Awel y Môr Offshore Wind Farm

Application Errata List (Clean)

Document Reference: 8.39

FIGURE NUMBER:
Figure 19

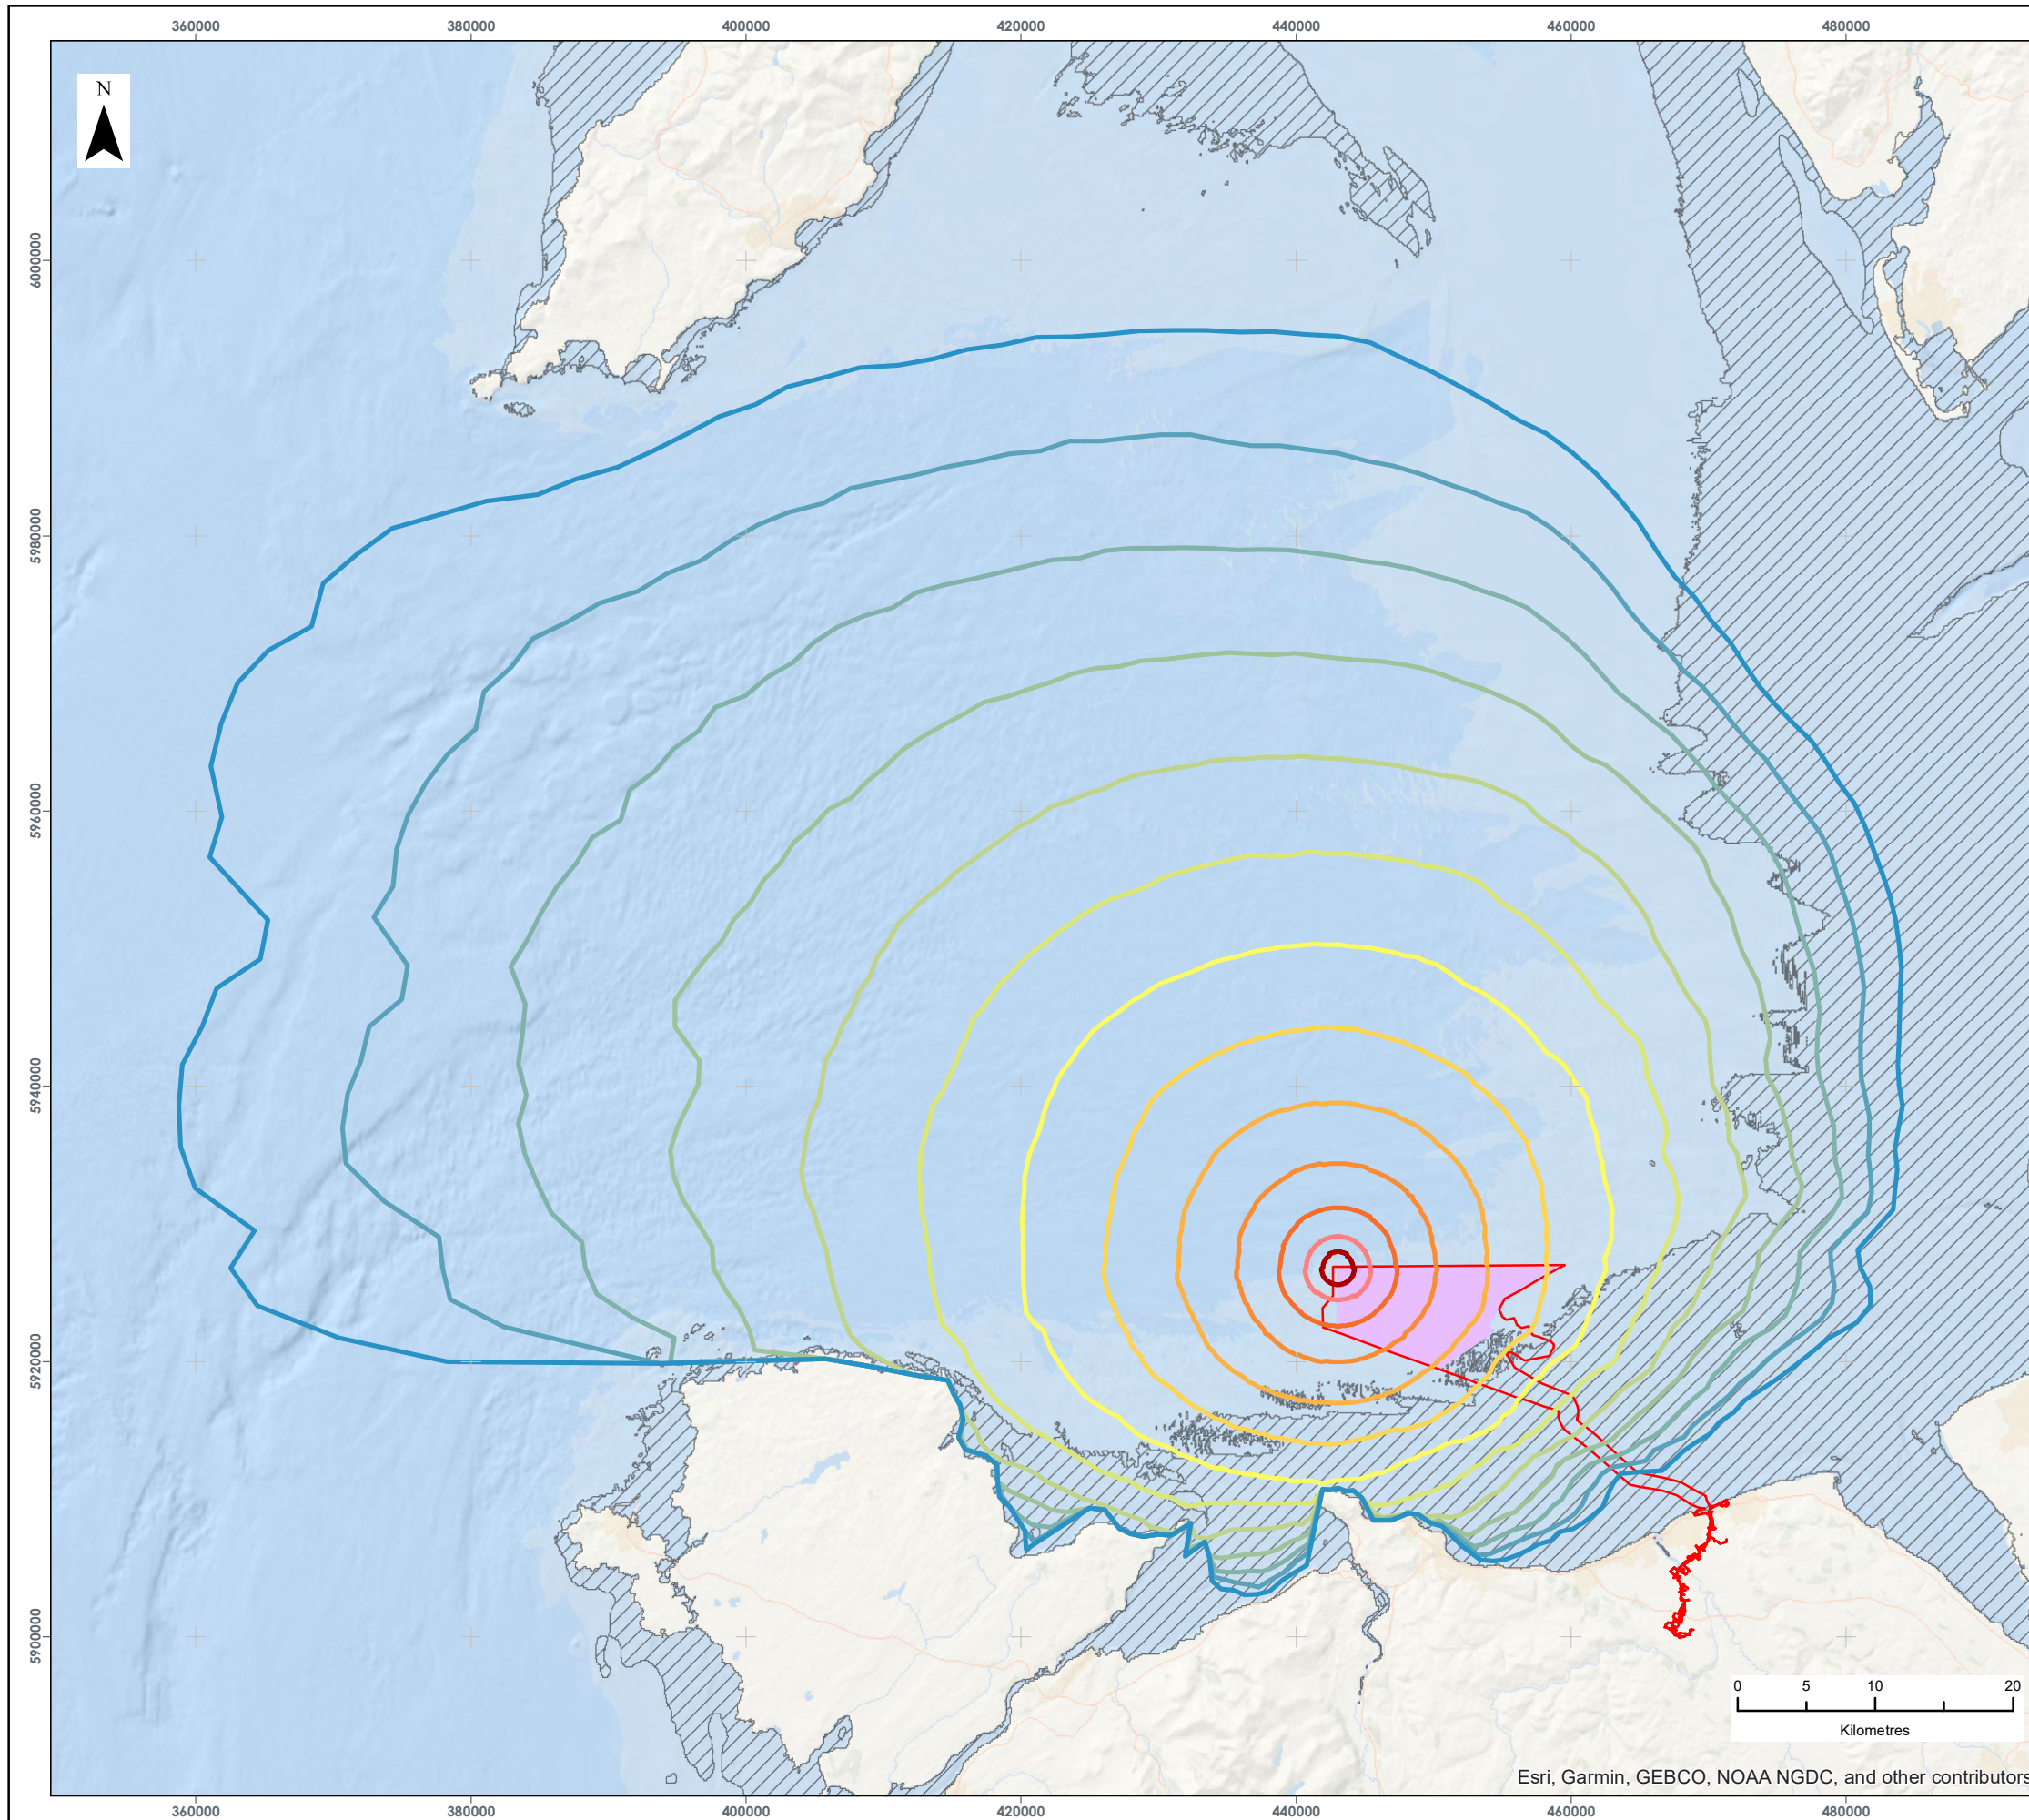
- ▲ Figure 19: Figure missing from AS-026 with Figure 21 incorrectly presented in its place. Corrected figure provided in Appendix A of this document. Note this figure is identical to Figure 19 presented in APP-053.

FIGURE NUMBER:
Figure 21

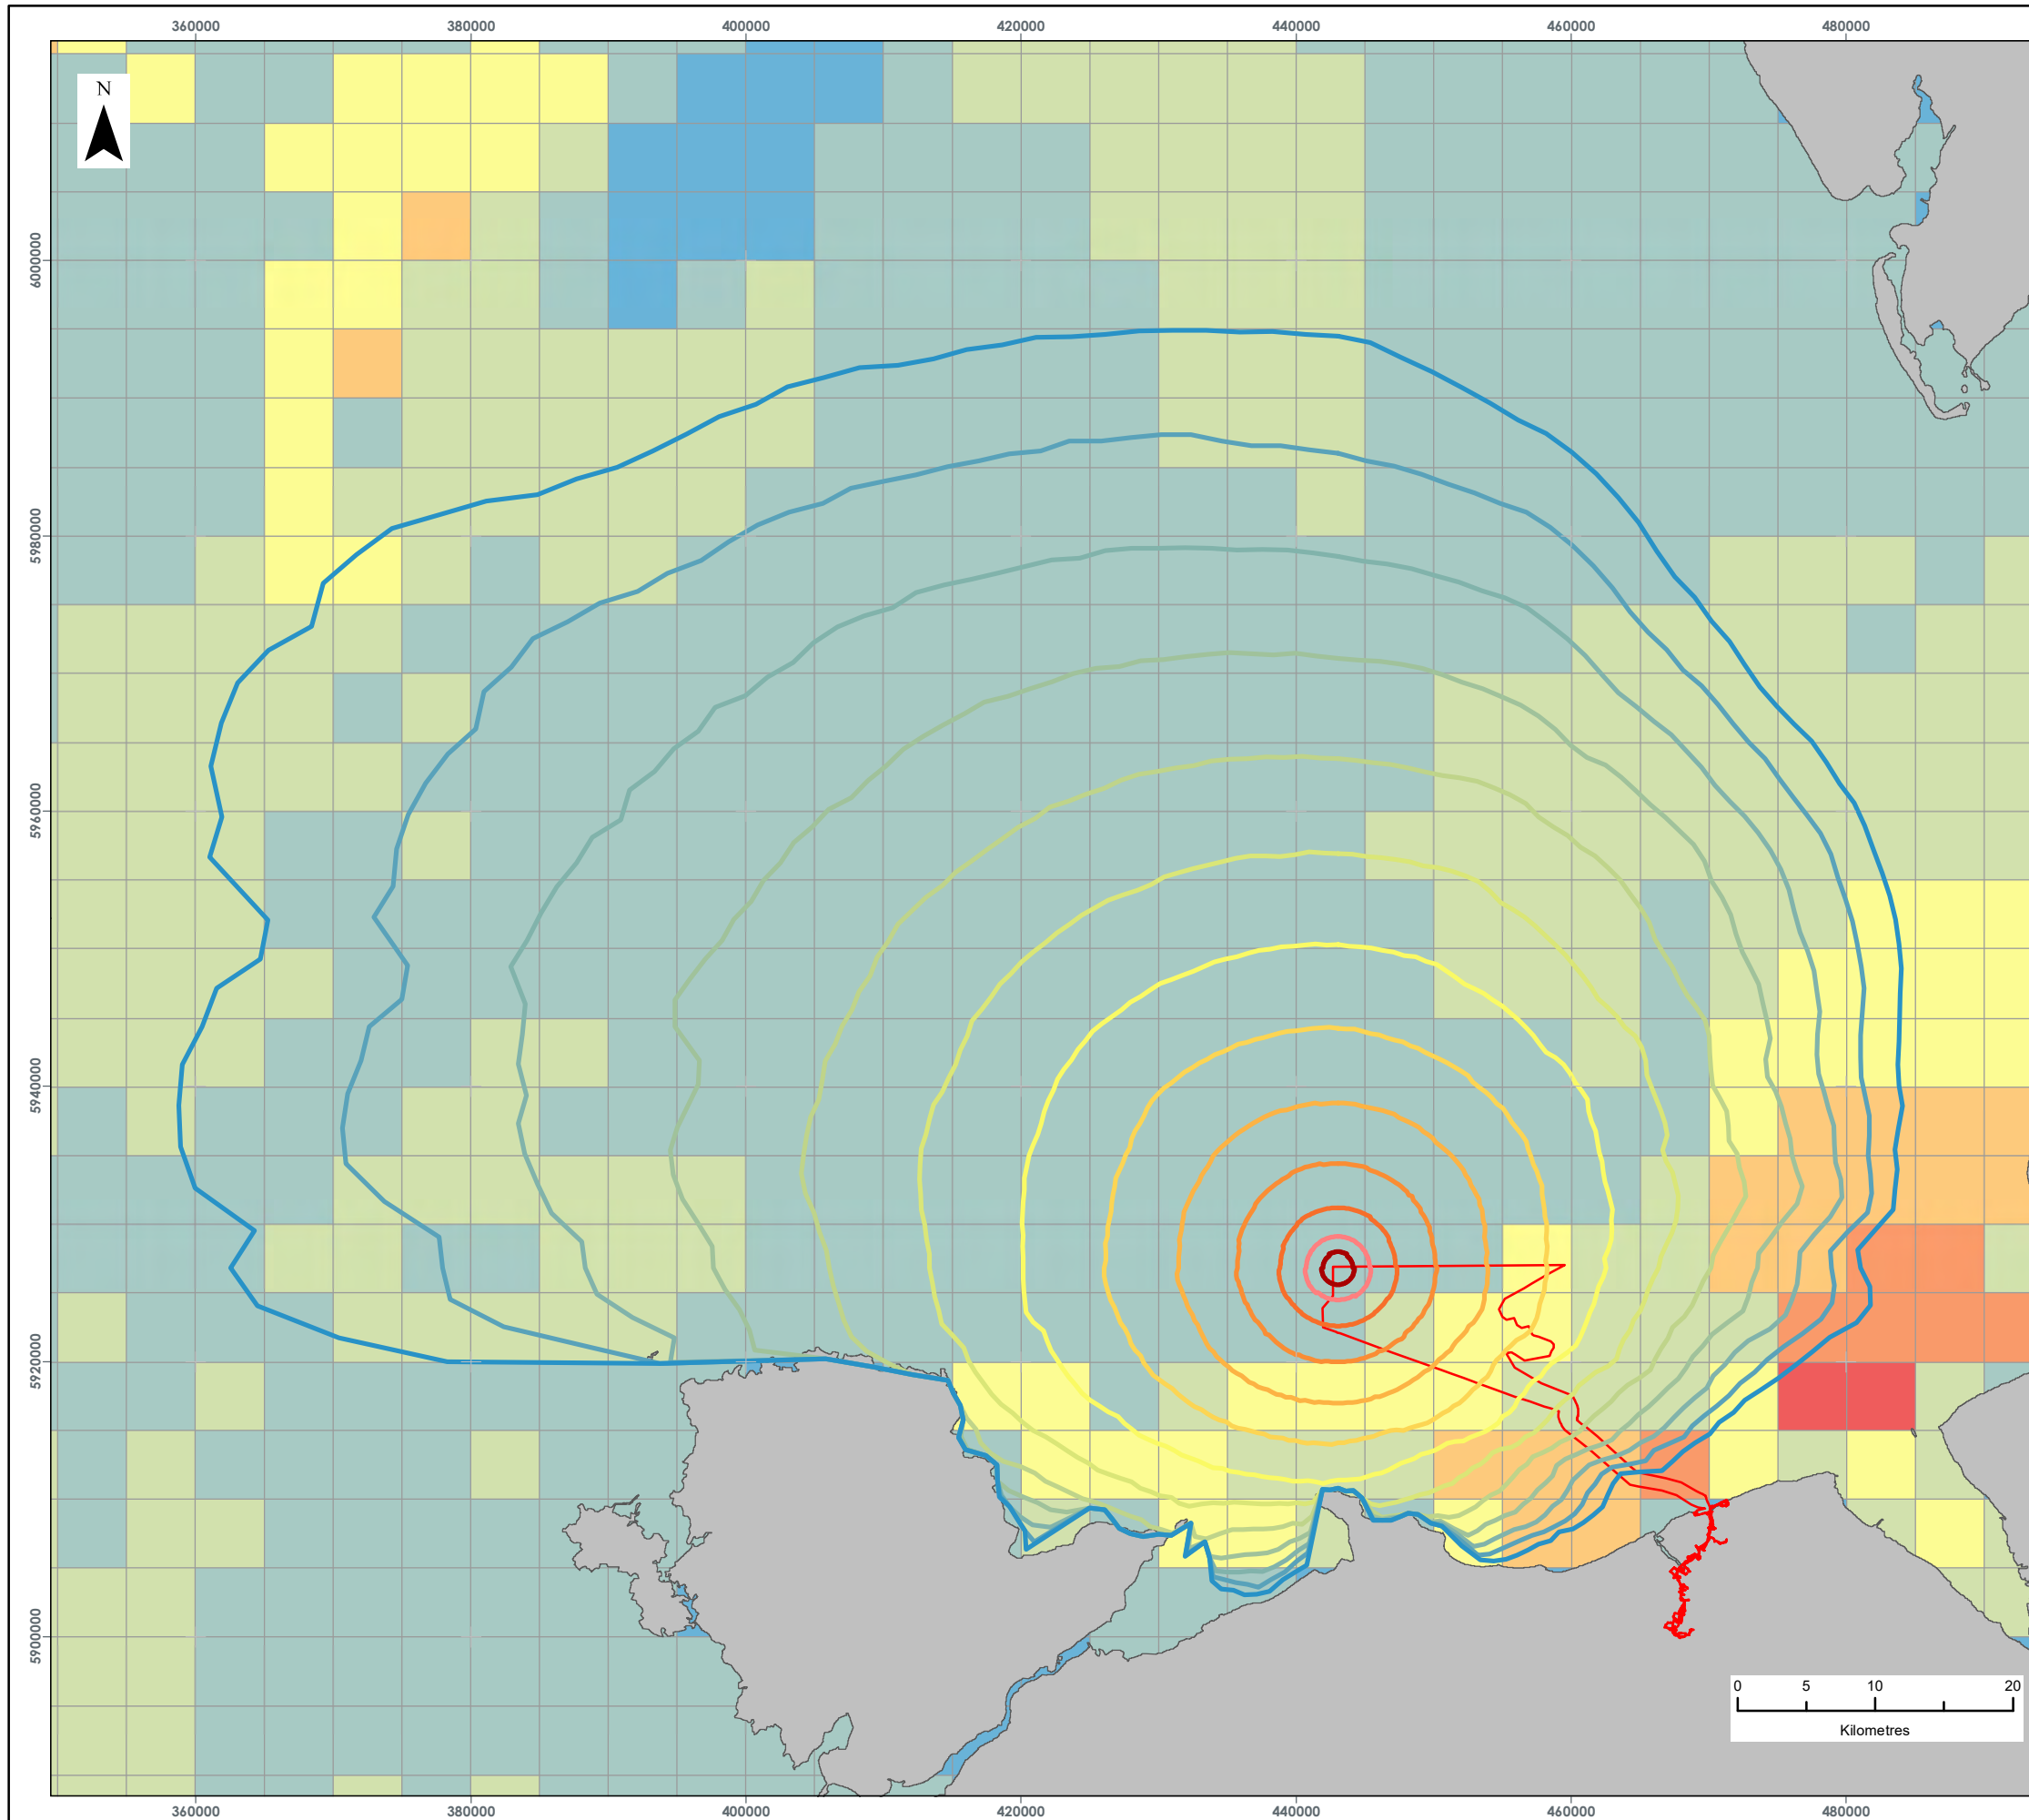
- ▲ Figure 21: Figure incorrectly displayed a partial black background and omitted base mapping. Figure was incorrectly presented in place of Figure 18. Corrected figure provided in Appendix A of this document. Note this figure is identical to Figure 21 presented in APP-053.
